Conceptual Review Agenda

Schedule for 08/17/15 to 08/17/15

Mulberry and Lemay Crossing Drive-Thru Restaurant

Re: Mulberry and Lemay Crossing - Drive-Thru Restaurant

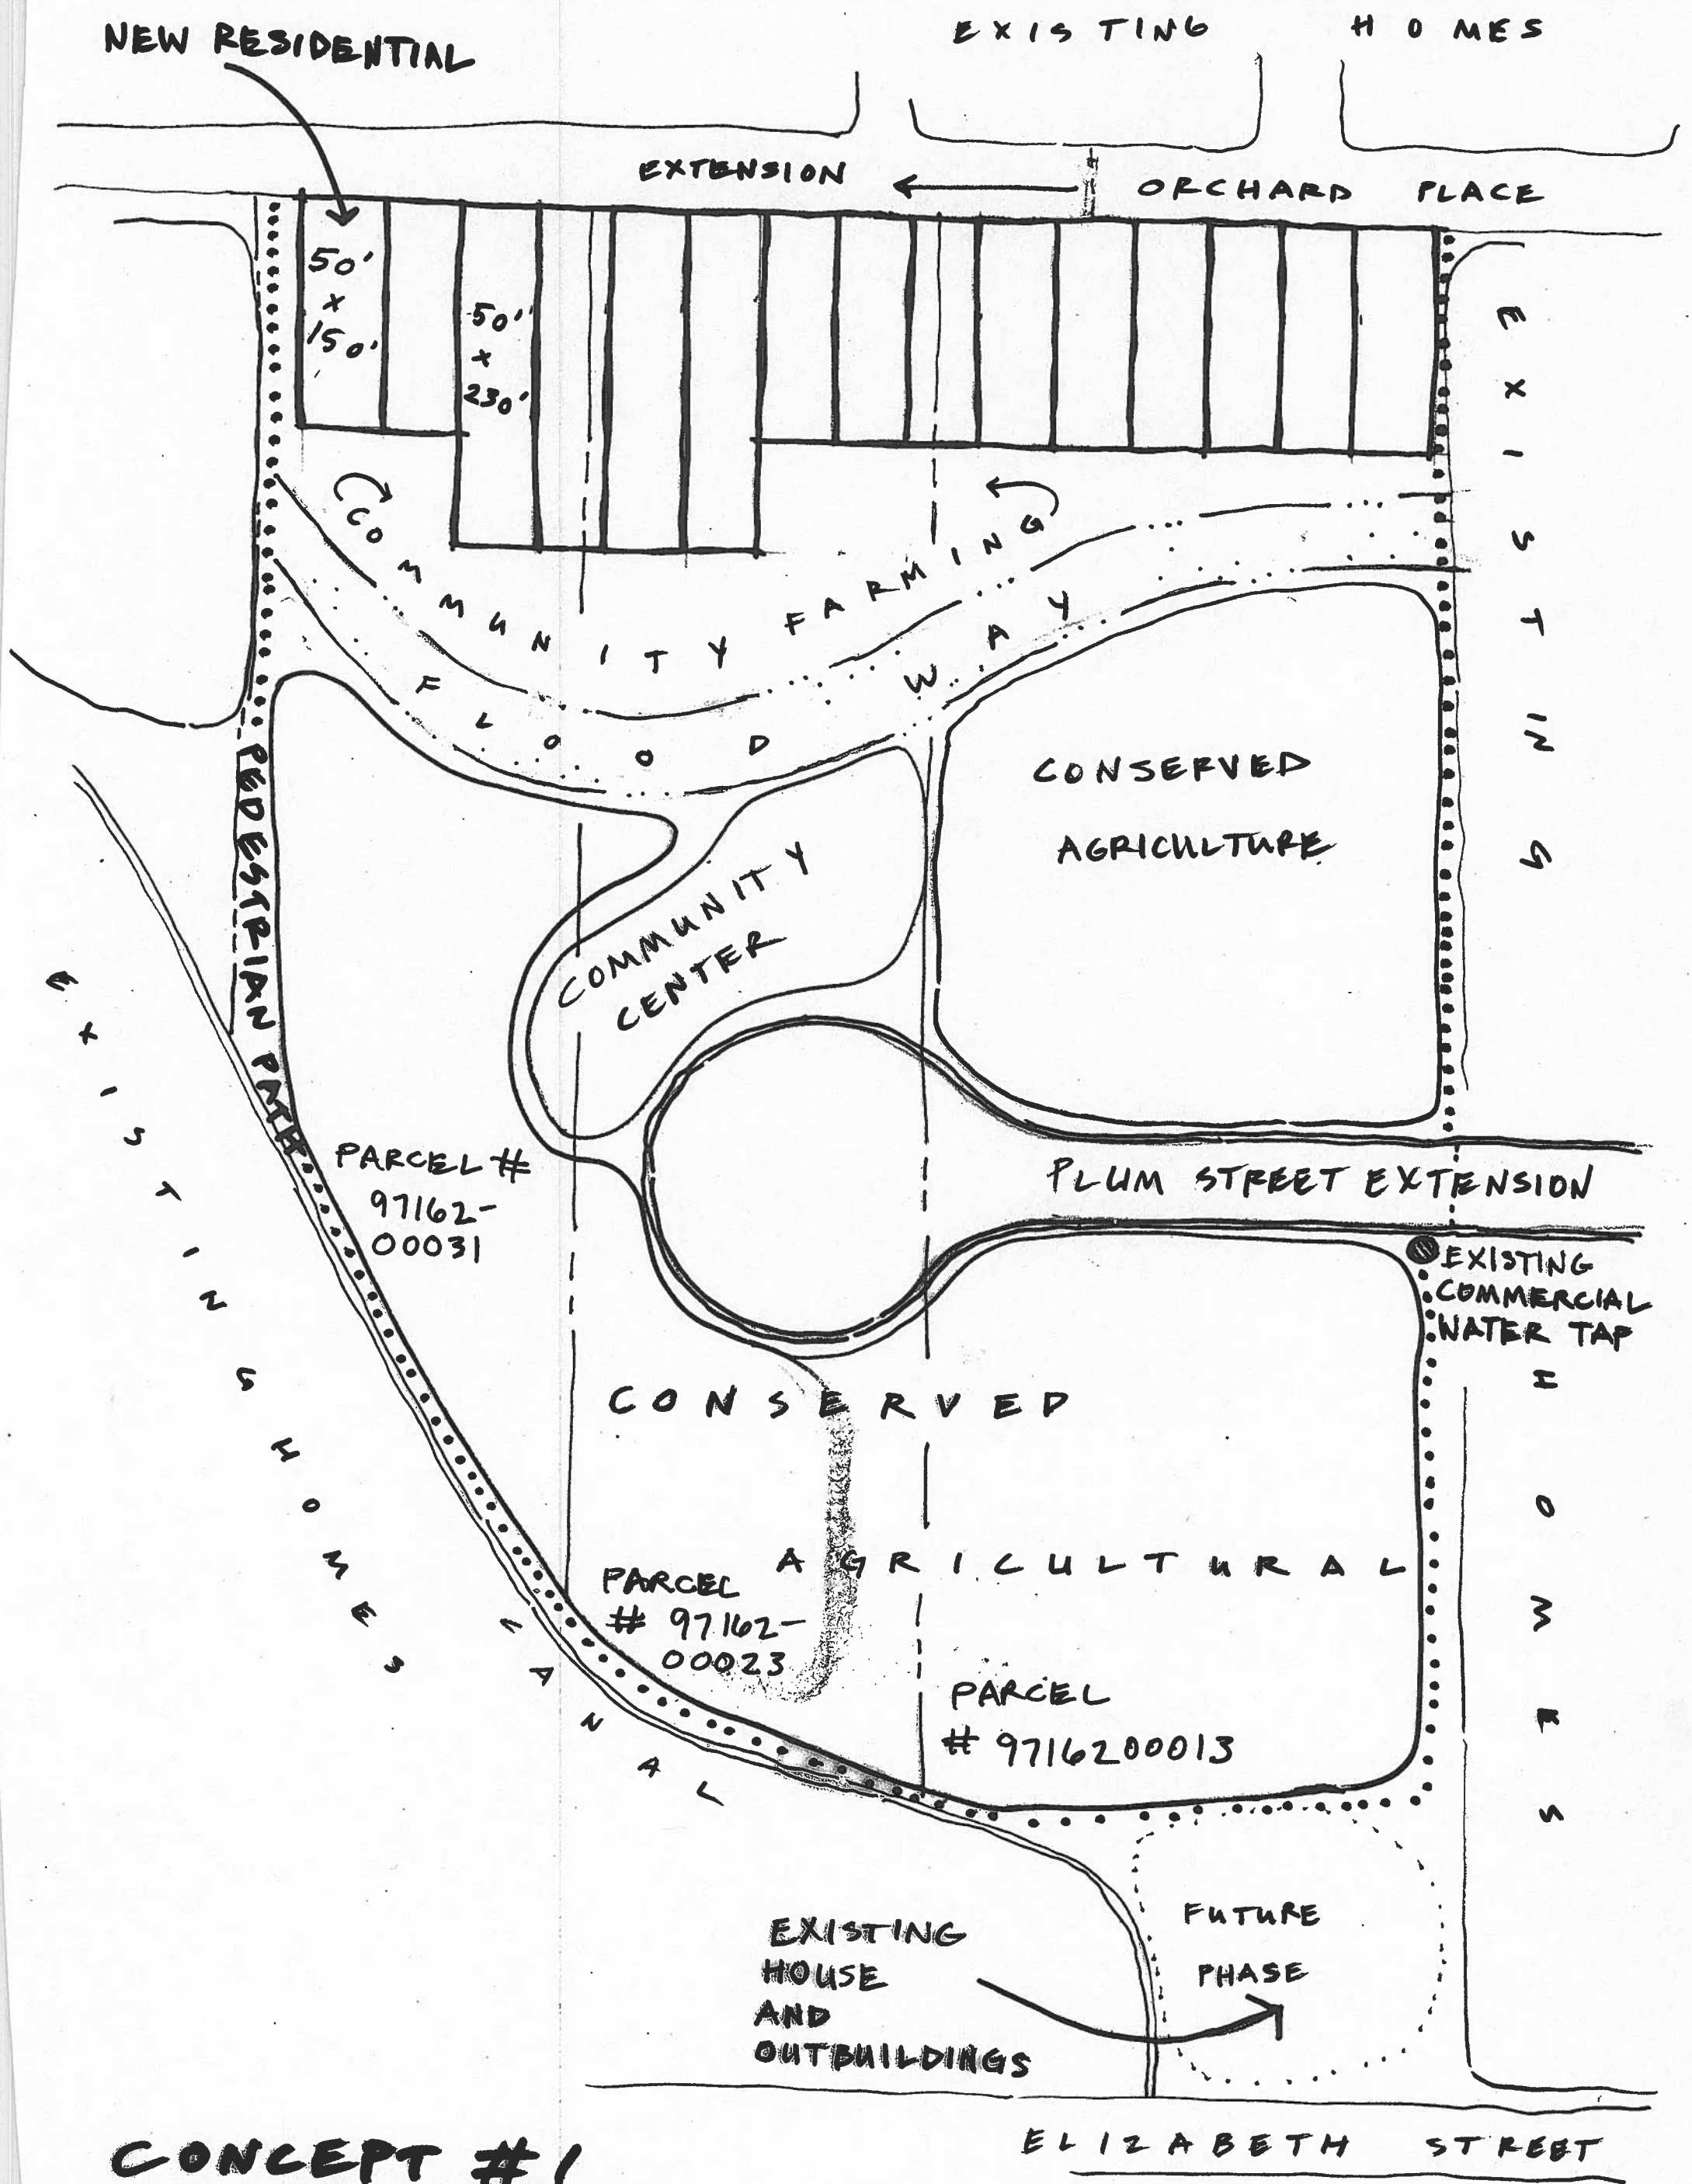
2. 2. Both alternative layouts in the applicants proposal show the existing floodplain being channelized across these properties to make room for this development. In order to alter the floodplain in that manner, a Conditional Letter of Map Revision (CLOMR) must be approved by the City Floodplain Administration prior to plan approval. That CLOMR must be prepared by a professional engineer licensed in the State of Colorado and must follow the City's floodplain modeling guidelines.

10. The pedestrian path shown in Concept #1 would help residents access nature, which is in line with the goals of the Nature in the City Strategic Plan. Please consider establishing a pedestrian connection to the Saddle Ridge Natural Area, as well.
11. How will the "conserved agriculture" area be managed? Are you planning on pursuing a conservation easement or another form of long-term protection for this portion of the property?
